## REMARKS

U.S. Serial No. 10/681,210  
November 12, 2004  
Page 2

IN THE DRAWINGS:

Figure 1

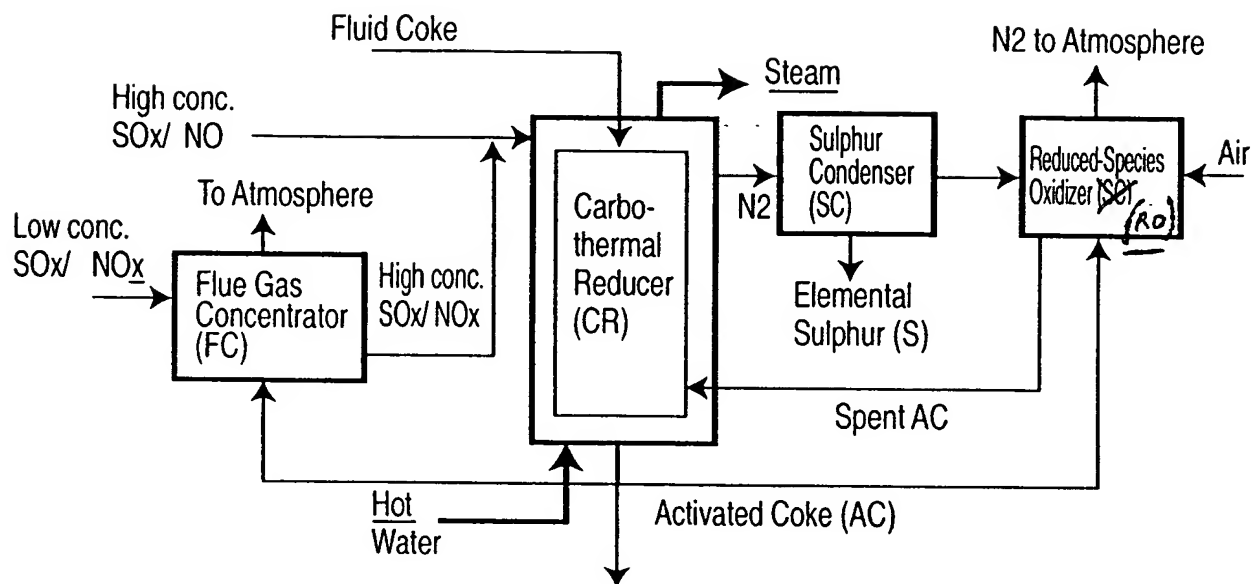
In response to the Examiner's objections to the drawings at paragraph 3, page 2 of the Office Action, Fig. 1 has been amended to replace "(SC)" with "(RO)", Fig. 2 has been amended to recite "°C", and Fig. 8 has been amended to replace "OC" with "°C", as set forth above and shown in the attached marked-up copy of Figs. 1, 2 and 8 entitled "Annotated Sheet Showing Changes." No new matter has been added. Accordingly, withdrawal of the objection to the drawings and entry of the attached Replacement Sheets of Figs. 1, 2 and 8 is respectfully requested.

In Fig. 1, please replace "(SC)" with "(RO)" as shown by the marked up Fig. 1 and clean sheet Fig. 1 attached herewith.

Figure 2

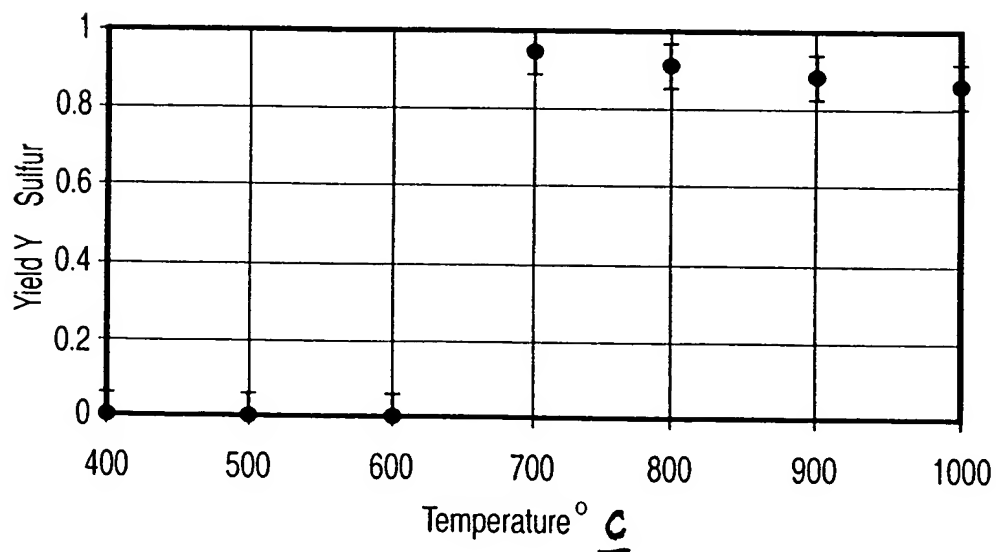
In Fig. 2, please add "C" as shown by the marked up Fig. 2 and clean sheet Fig. 2 attached herewith.
